**PERMIT TRACKING FORM**

Date Received: 1/30/98	By: PFO	PERMIT NUMBER	ACT/007/038
Title of Proposal: Degassification Well		PERMIT CHANGE #	97K-1
Description:		PERMITTEE	Cyprus Plateau Mining Corp
# Copies Required: 5	# Copies Received: 5	MINE NAME	Willow Creek Mine

RE: Submittal of Two Additional Copies, January 29, 1998, Degassification Wells, Cyprus Plateau Mining Corporation, Willow Creek Mine, ACT/007/038-97K, File #2, Carbon County, Utah

Title of Application:  Addition of two methane degassification wells and mine layout revision.	Permit Number: ACT/007/038
	Mine: WILLOW CREEK
	Permittee: CYPRUS PLATEAU

Figure 4.5-17

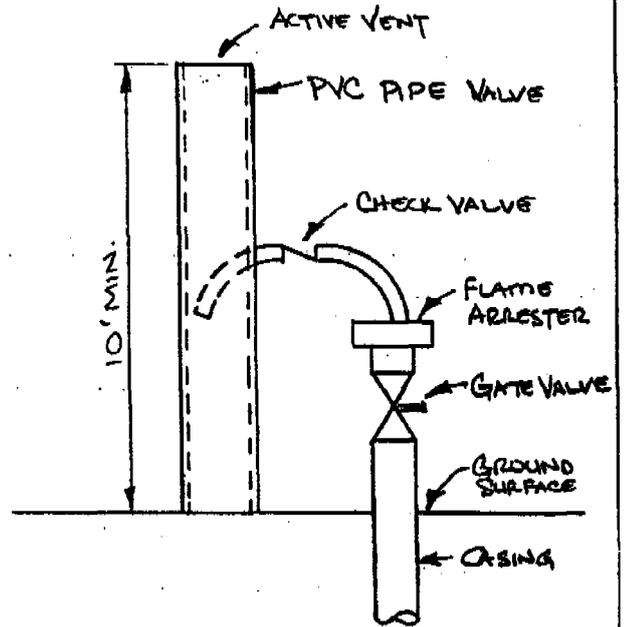
Two longwall gob degassification wells are needed to reduce the risk of methane gas ignitions and possible mine fires. The locations of the wells are shown on Map 19A, Mine Plan D-Seam. And on Map 30, Degassification Wells Surface Facilities Map. A detail of the degassification wells can be found on Figure 4.5-17. These degassification wells will be permitted through the Bureau of Land Management since they will lie on BLM land. The BLM requires that they be permitted under an exploration permit. Authority for the wells falls under federal regulations and case law which provide for degassification of methane for health and safety reasons. A gas company has expressed interest in developing the gas for commercial purposes if it is of adequate quality and quantity. The gas company will test the vented gas during initial venting and may develop the wells in the future. Permitting of the gas development project by the gas company will be done by the gas company in the future.
